*Private Fuel Storage, L.L.C.*

June 15, 1998

**SUPPLEMENTAL RESPONSE TO RAIs  
PRIVATE FUEL STORAGE FACILITY  
DOCKET NO. 72-22 / TAC NO. L22462  
PRIVATE FUEL STORAGE L.L.C.**

Plate 2. — MAP SHOWING THE GENERALIZED DISTRIBUTION OF DISSOLVED SOLIDS IN GROUND AND SURFACE WATERS, THE CHEMICAL CHARACTER OF REPRESENTATIVE WATER SOURCES, AND THE RELATION OF QUALITY TO THE SOURCES OF RECHARGE AND THE AREAS OF DISCHARGE IN SKULL VALLEY, TOOELE COUNTY, UTAH

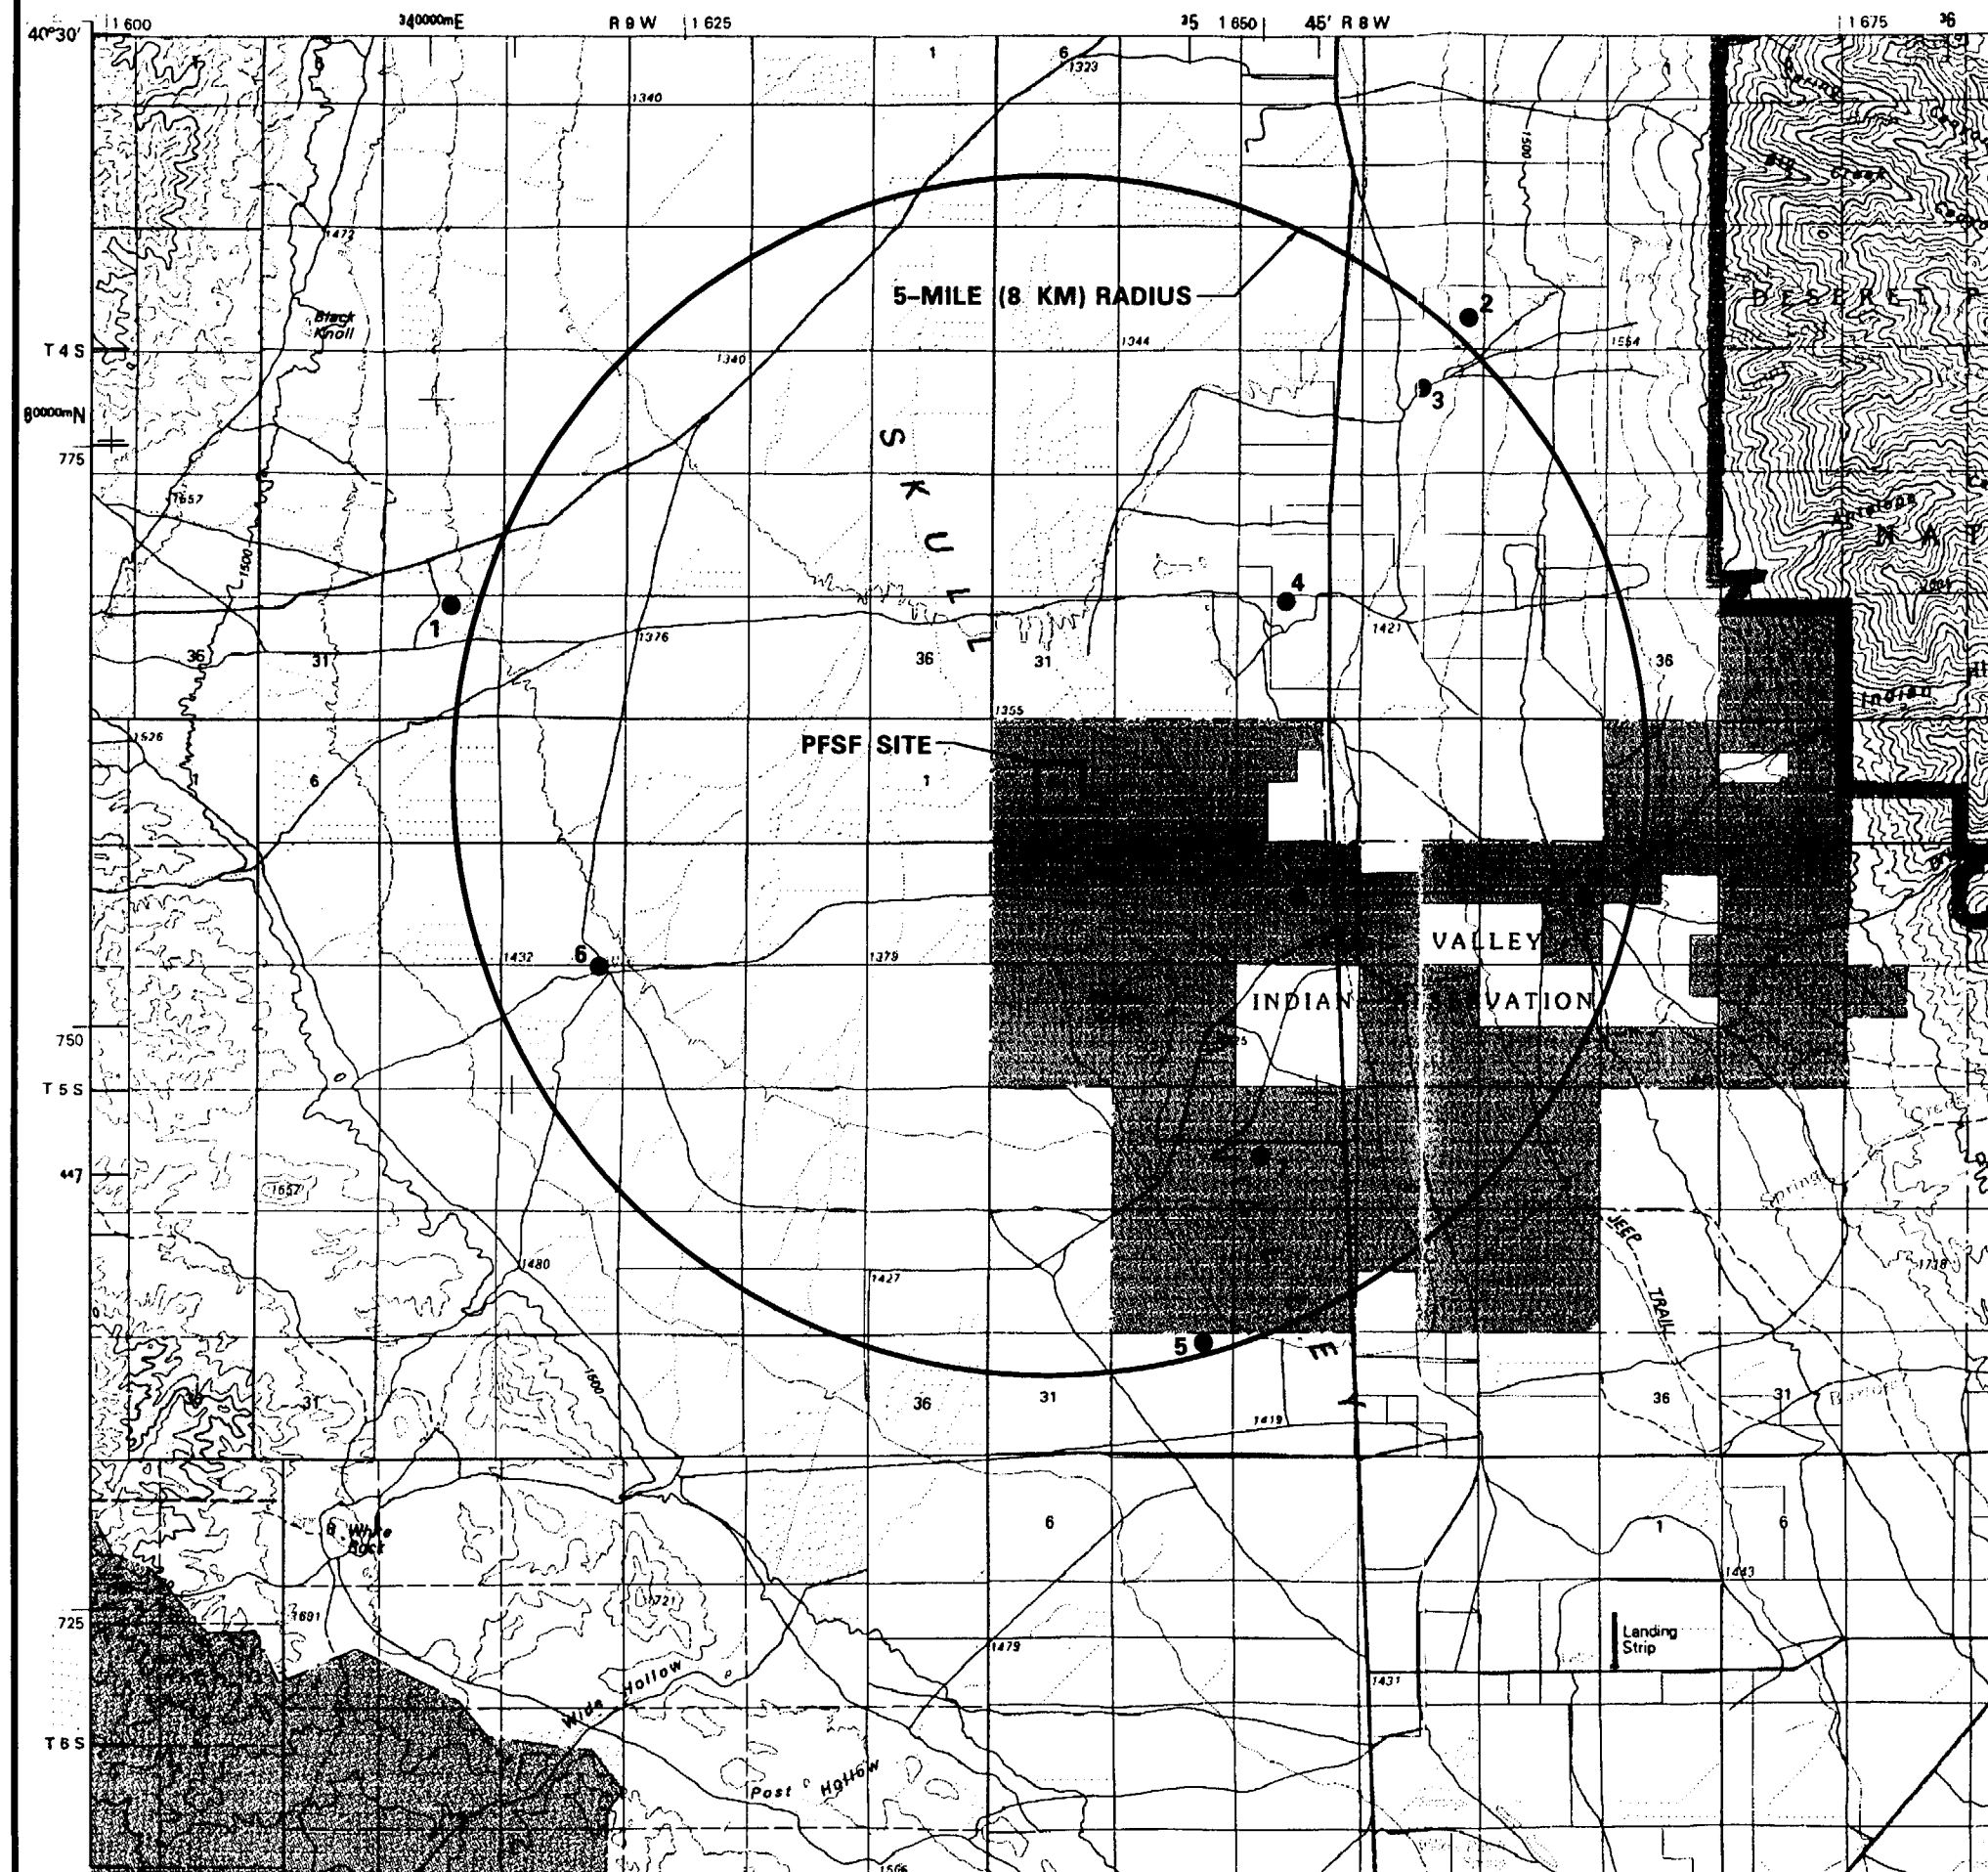
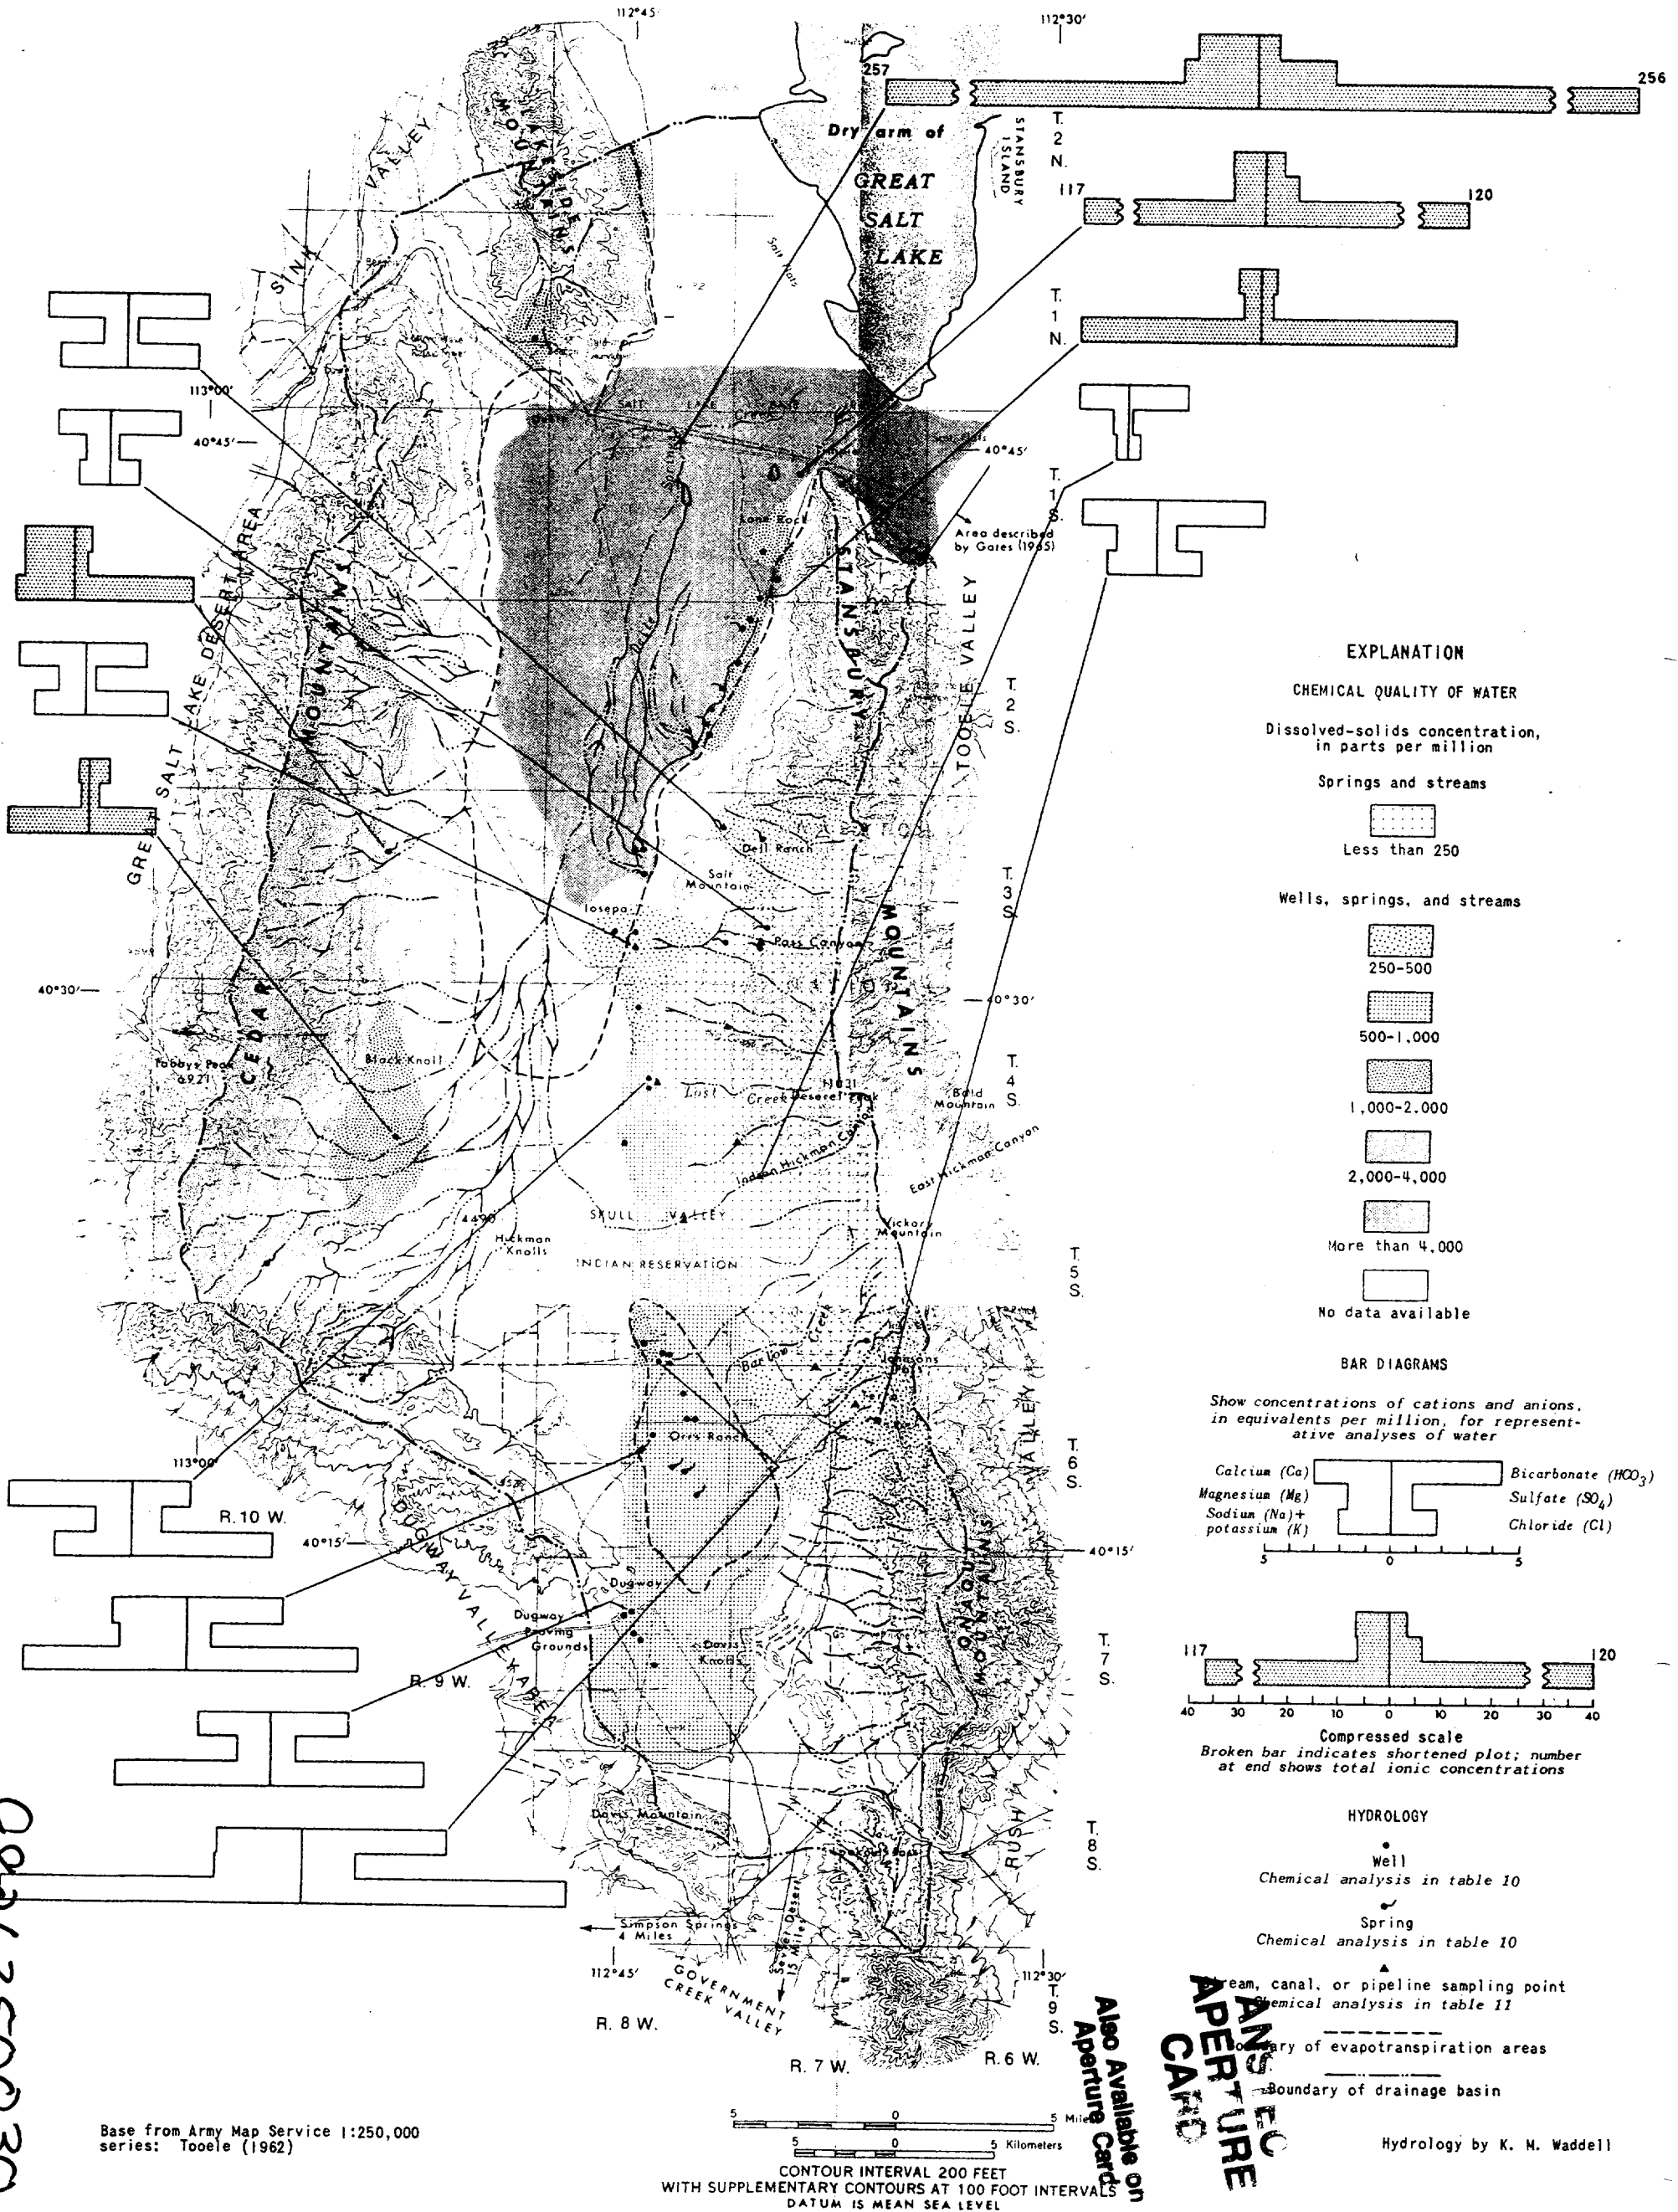
- (d) Potentiometric contours of groundwater at and around the proposed PFSF site (if relevant).
  - (e) Classification of the aquifer beneath the PFSF site based on class of use and water quality (if relevant).

- (c) See response to (a), above.
- (d) The potentiometric map (Plate 1) from Hood and Waddell is included as part of this response.
- (e) The State has not applied an aquifer classification system to the aquifer in Skull Valley. A water quality map (Plate 2) from Hood and Waddell is included as part of this response.
